## Determination 2013/006

### Regarding the issue of a code compliance certificate for a house and timber retaining wall at 16 Highland Drive, Richmond

Figure 1: Part-plan of the house and retaining wall as consented

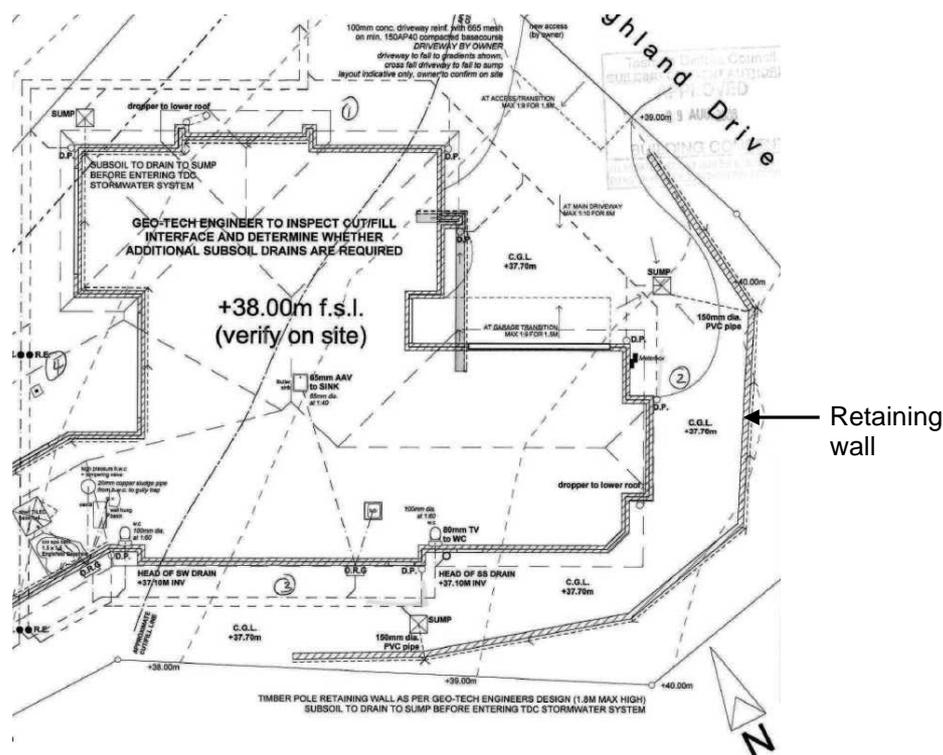
9.2.1 The consented plans show a flat area between the house and the retaining wall, and the driveway extending past the garage entrance and extending out toward the retaining wall. I note the plans do not specifically note the space between the house and the retaining wall as a vehicle parking area, but there is clearly a relationship intended.

9.2.3 Regardless of the above, the fact is the as-built level of the retaining wall relative to the house is substantially different from that which was consented. The height difference has resulted in the area sloping down from the retaining wall to the house.

Figure 3: Sections through the wall, as designed and as-built, taken from the engineer's drawing as received by the authority

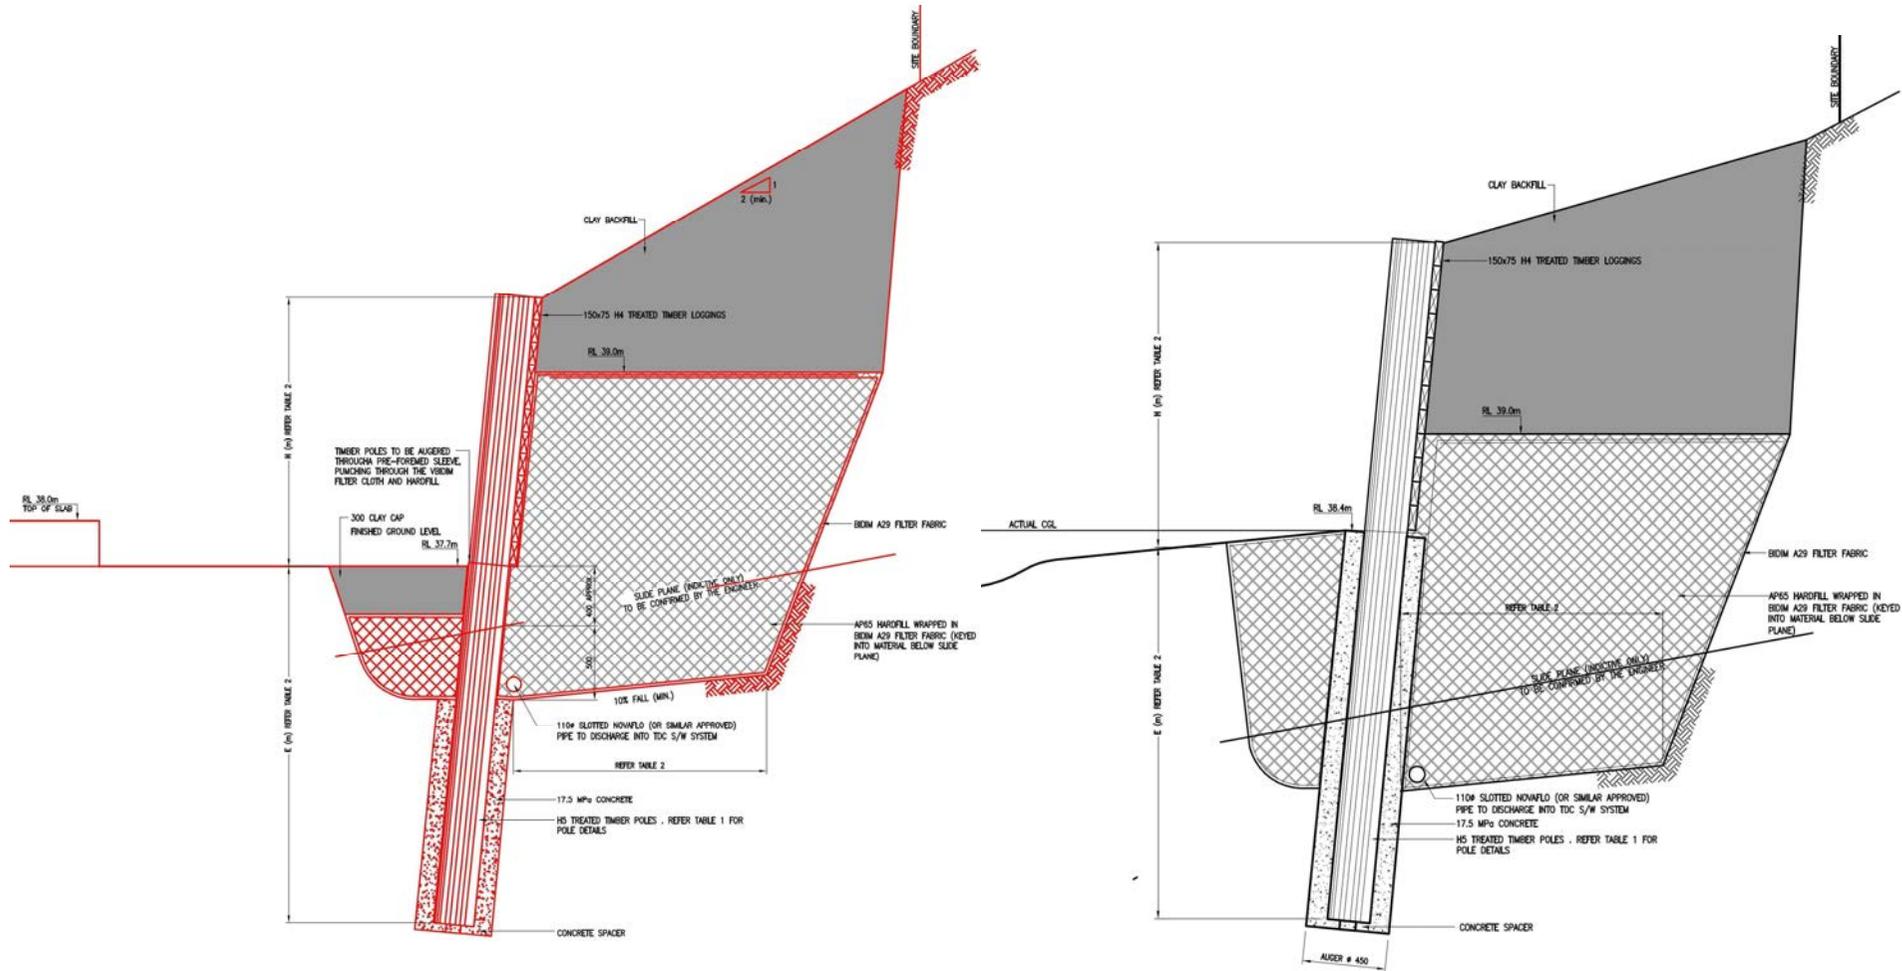
- 6.4 The expert found that the retaining wall, including the shear key and the drains, had been built at a higher level than designed relative to the survey datum, but in all other respects the building work was in accordance with the approved plans. The expert put the increase in height at between 700mm and 1 metre. This also resulted in the retaining wall being higher than planned relative to the house.

The facts remain the shear key was constructed 1000mm above the levels required to secure the known [shear plane] which runs across the site.

- 9.3.1 The fact that the retaining wall has been built higher than consented in relation to the datum point is not disputed by the parties. I accept the findings of the expert that the height variation is approximately 700mm to 1000mm higher relative to the survey datum.
